# Errata Sheet

**Product Family:** DL405 **Date:** December 11, 2018  
**Manual Number:** D4-USER-M  
**Revision and Date:** 4th Edition, Rev. A; March 2013

**Other Sources of Information**

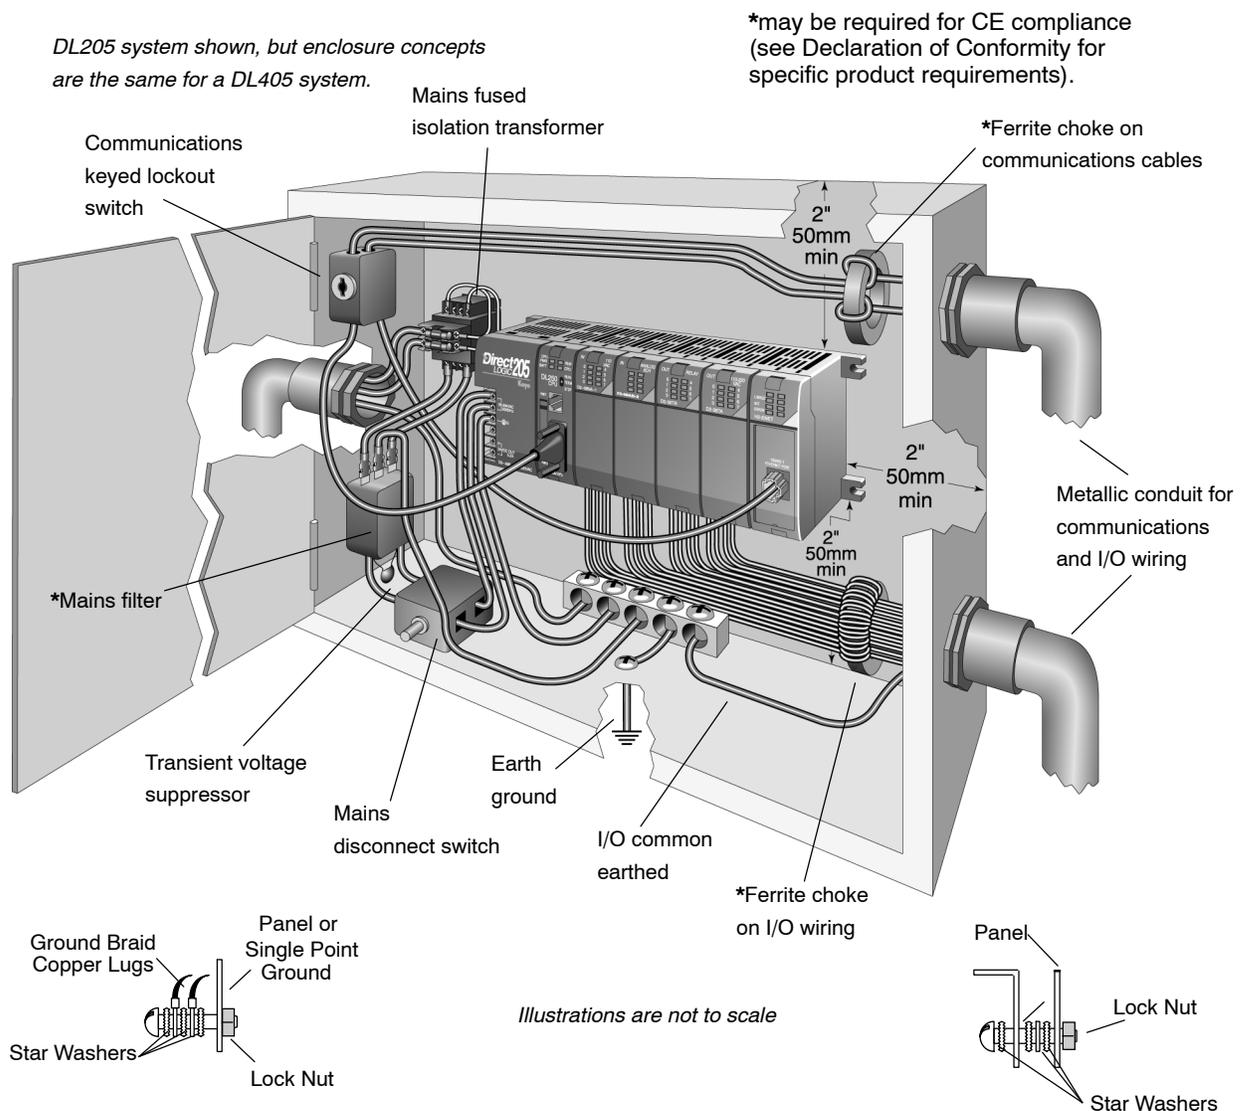
See Errata Sheet at the beginning of this file. Replace the text in this box with the updated website urls and information provided.

*Replace the text that follows the sentence "It may be possible to obtain this information locally; however, the official source of applicable Directives and related standards is:" with the following updated information:*
